**Exhibit A, Draft Conditions of Approval
Vesting Tentative Subdivision Map 7968**

**4171 and 4189 Stanley Boulevard
July 11, 2012**

Planning Commission Second Staff Report

PURPOSE: Application for Rezoning of an approximately 1.17-acre site located at 4171 and 4189 Stanley Boulevard from R-1-6,500 (One-Family Residential) District to the PUD-HDR (Planned Unit Development – High Density Residential) District and for Planned Unit Development (PUD) Development Plan approval to construct 13 detached single-family homes.

TRACT 7968
GRADING AND DRAINAGE PLAN

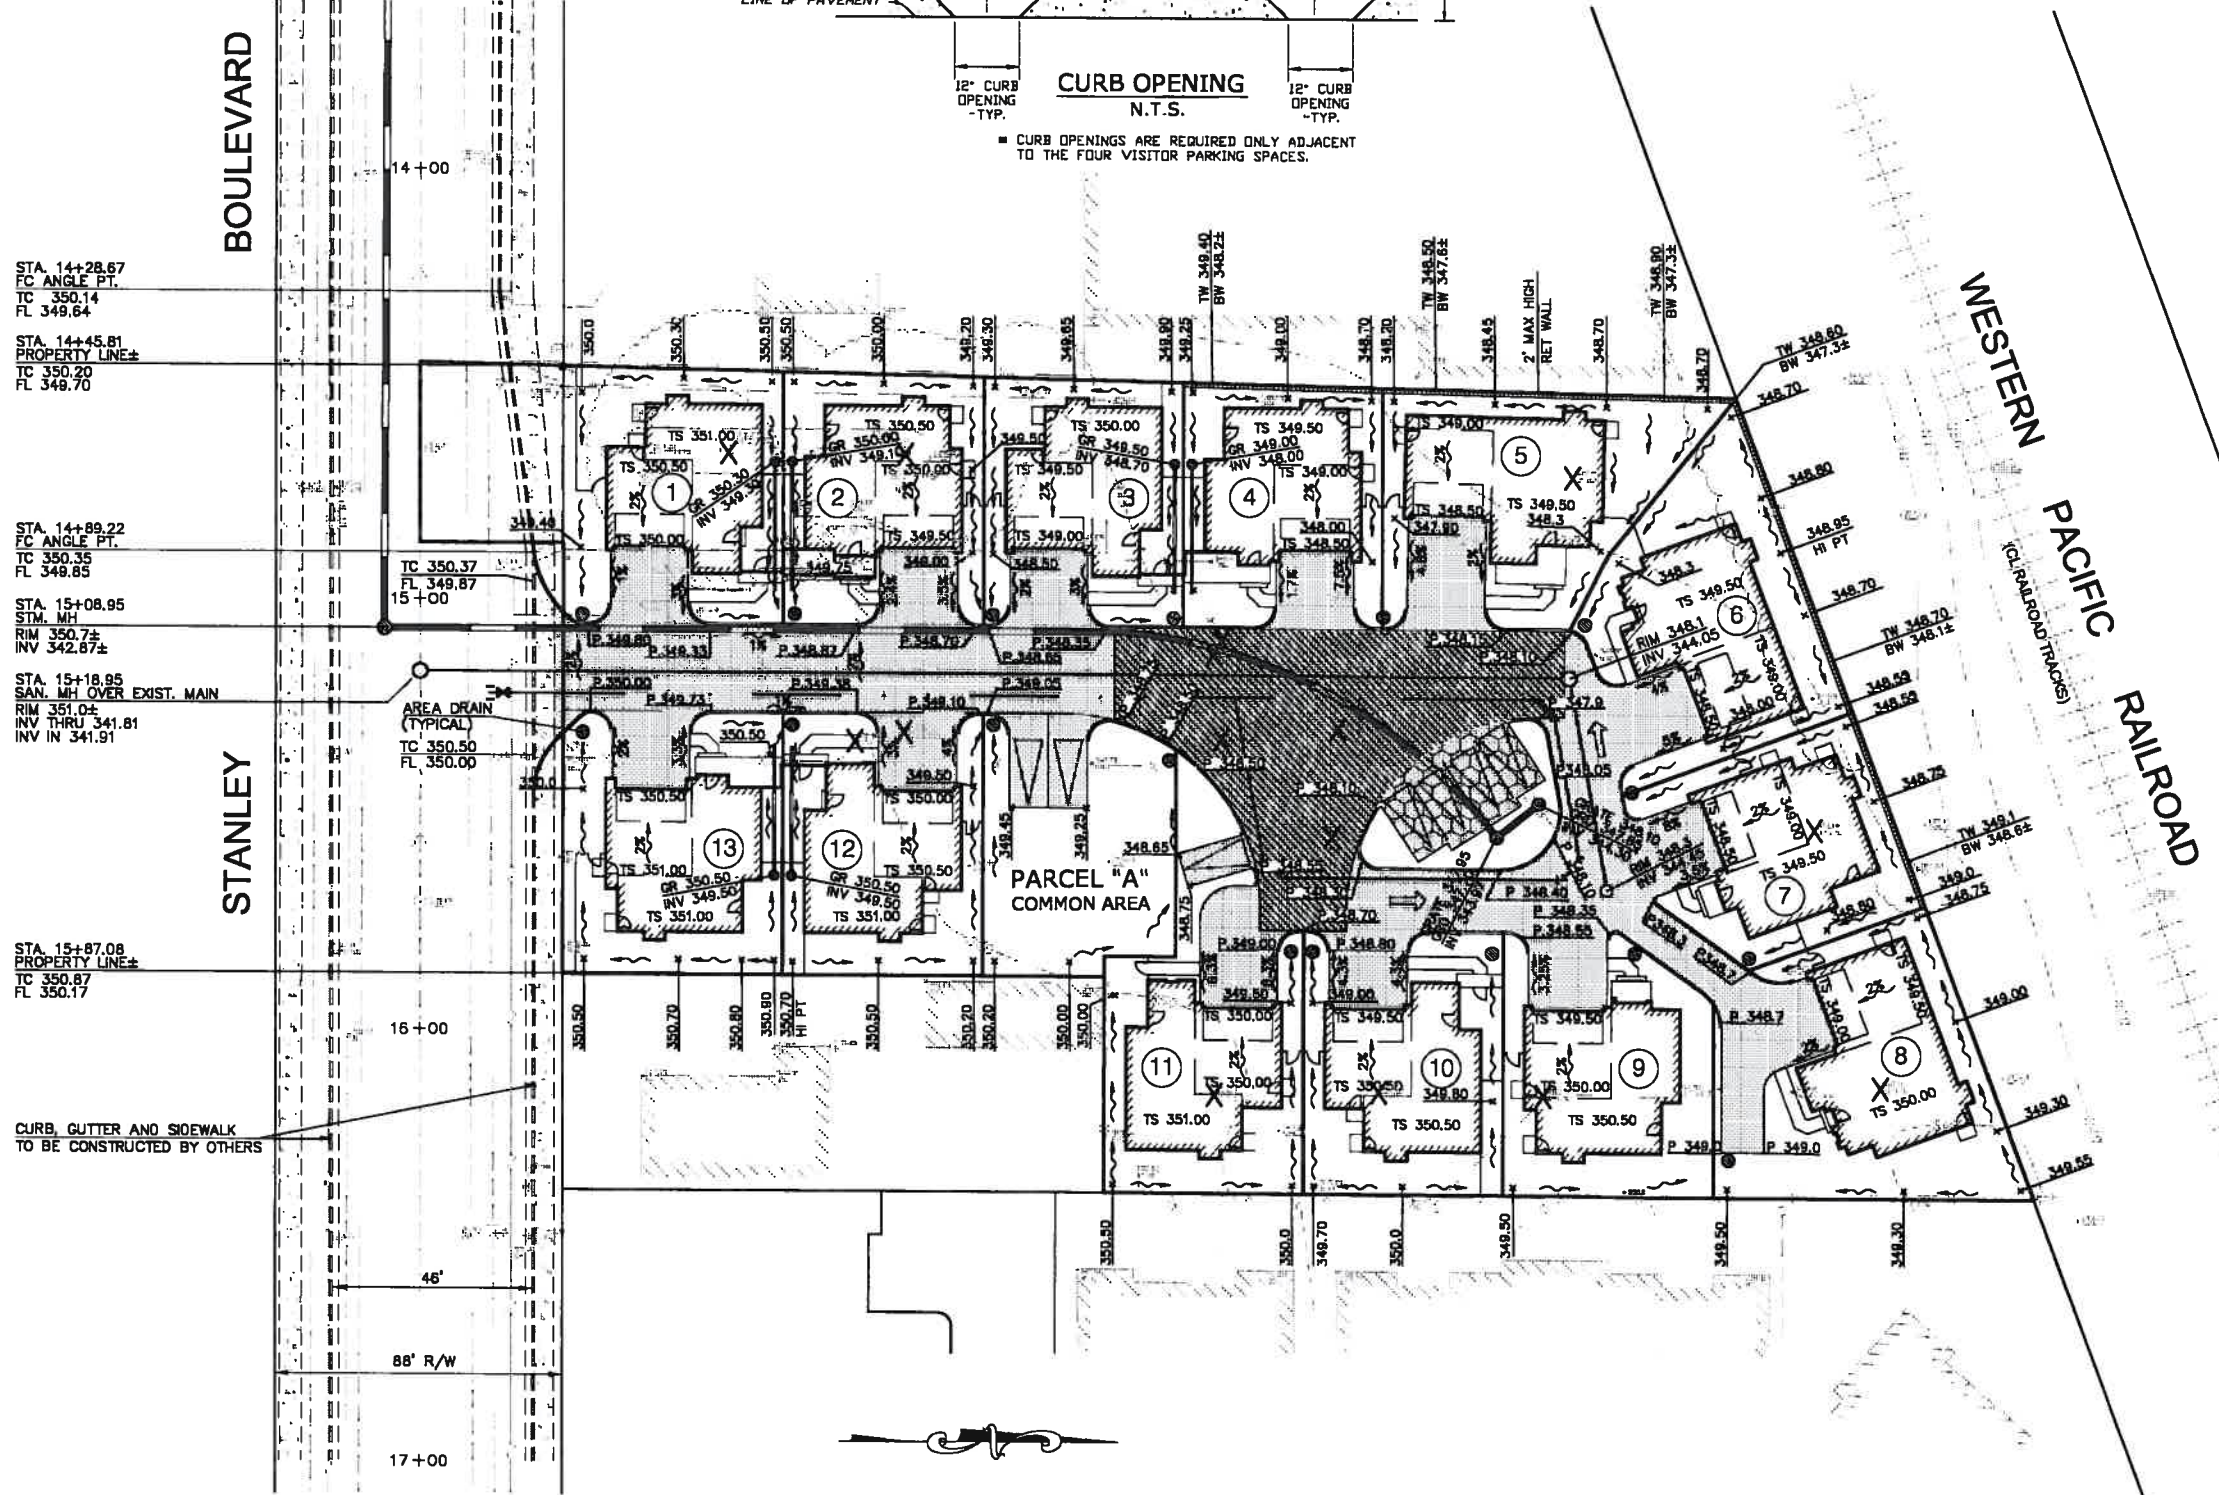
9. The on-site storm drain system shall be designed with an overland release from the central landscape area across Lot 6, 7, or 8 to the Union Pacific Railroad right-of-way, or shall be designed with an on-site storm drain sump to receive the overflow. If the subdivision is designed with an overland release, the subdivider shall locate the release in an easement on the private lot and shall obtain an easement from the Union Pacific Railroad to receive the runoff. If the on-site storm drain system is designed with a sump, the on-site storm drain system shall be designed for a 50-year storm event. The overland release or the collection sump shall be shown on the improvement plans submitted with the Final Subdivision Map.

Figure 4: Present Proposal – 13-Unit Development Plan

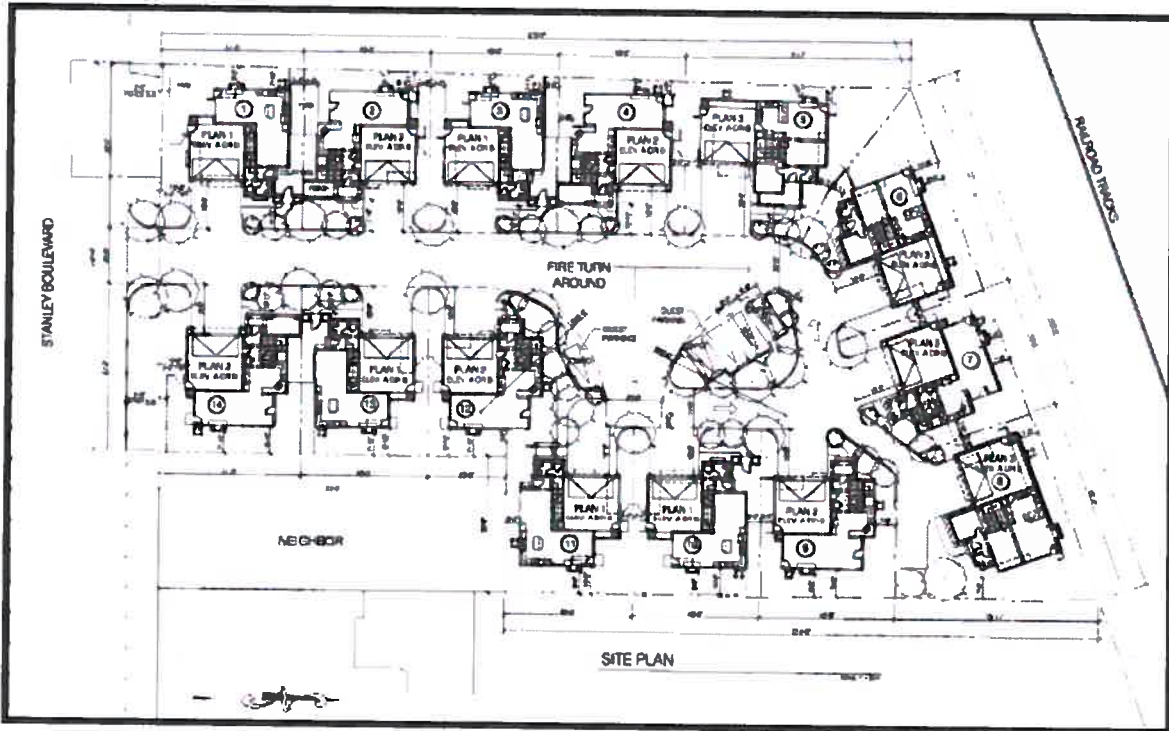
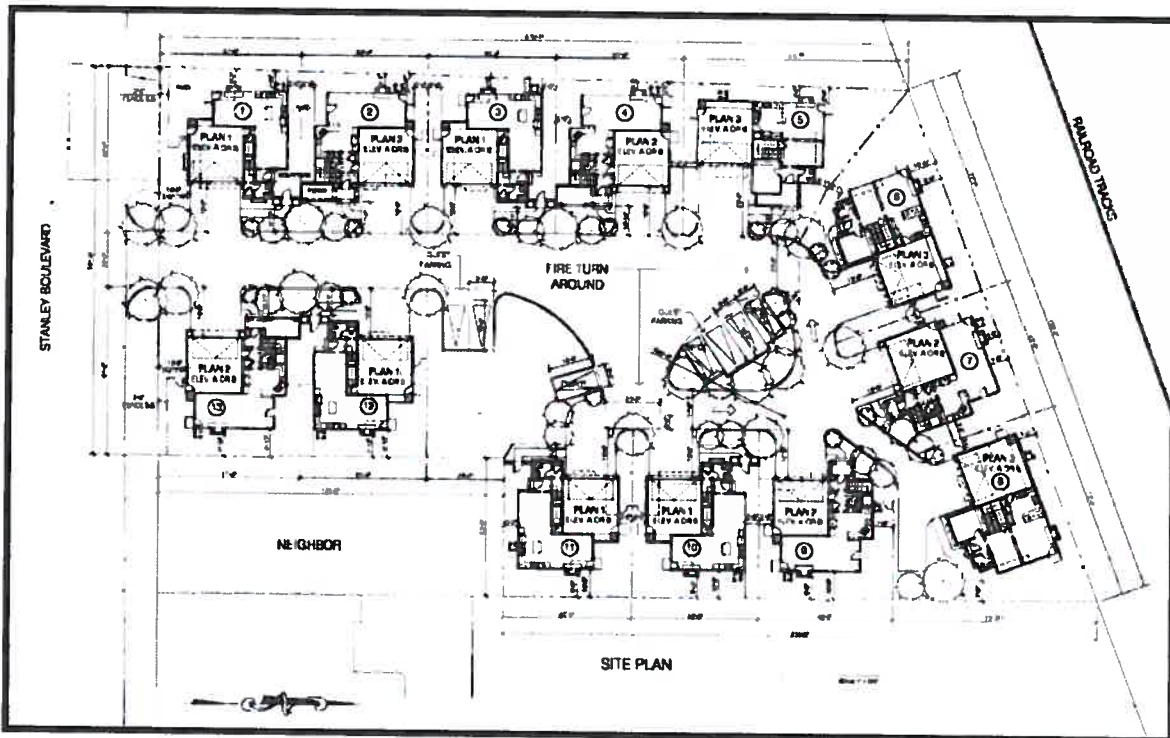
Commissioners Blank, O'Connor, and Pentin wanted a further reduction in density from the 13 units of the revised development plan to 12 units. Chair Narum stated that she could support 13 units, if the applicant reduced the house sizes and floor area ratios and increased the building setbacks. Commissioner Pearce concurred with a reduction in density but stated that she could support an increase in density for non-single-family homes with decreased living space and increased open space. Commissioner Blank added that a further decrease in density will provide an increase in open space, preserve additional trees, and, perhaps, reduce shading of the photovoltaic panels on the adjacent neighbor's property.

Chair Narum stated that the proposed house sizes and floor area ratios are too high and suggested decreasing the house sizes in order to increase the rear yard setbacks and to provide additional open space. Commissioner Pearce wanted to

The Planning Commission preferred the central location of the common open space area. The commission believed that further reducing the project density would allow the open space area to be increased in size. Guest parking should not encroach into the common open space area. The Planning Commission also discussed the pros and cons of common area maintenance by a Maintenance Association or by a Homeowners Association. The Commission also stated that play equipment for children should be provided in the open space area.

The applicant has not reduced the density of the proposed development from the 13-unit plan that was reviewed and discussed by the Planning Commission at the work session.

The applicant has not reduced the house sizes or changed the type of housing of the proposed development plan from the plan that was reviewed and discussed by the Planning Commission at the work session.

The proposed 13-unit development plan places the common open space area in a central location on the site. The size of the open space area has not changed from the plan that was reviewed and discussed by the Planning Commission at the work session. The applicant has agreed to a condition requiring a Homeowners Association be created to maintain the development's common open space area and other common areas and utilities. The applicant did not propose play equipment in the open space area. Staff has added a condition requiring play equipment for the open space area. The applicant does not concur with this requirement and will speak on this issue at the public hearing.

Figure 5: Previous site plan with accessory structure at 4151 Stanley Boulevard

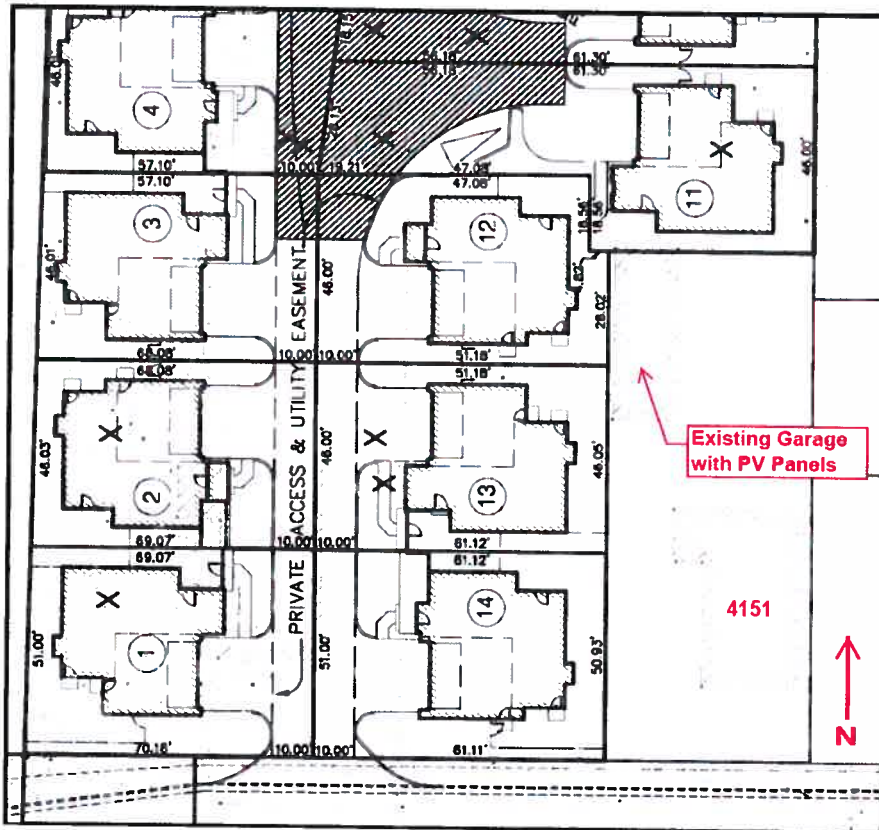
Provide shade trees where feasible but minimize or avoid to the greatest extent feasible shading the adjoining neighbor's photovoltaic panels.

The applicant proposes one flowering accent tree and six small accent trees on the east side of the open space area by the detached garage with Mr. Walterson's photovoltaic panels. The landscape plan states that the tree height for the flowering accent tree on the southeast corner of the open space area should, "...remain clear of neighboring solar sunlight" shown on the east side of the common open space area. Staff has included a condition that the tree and shrub species selected for the open space shall not block Mr. Walterson's photovoltaic panels.
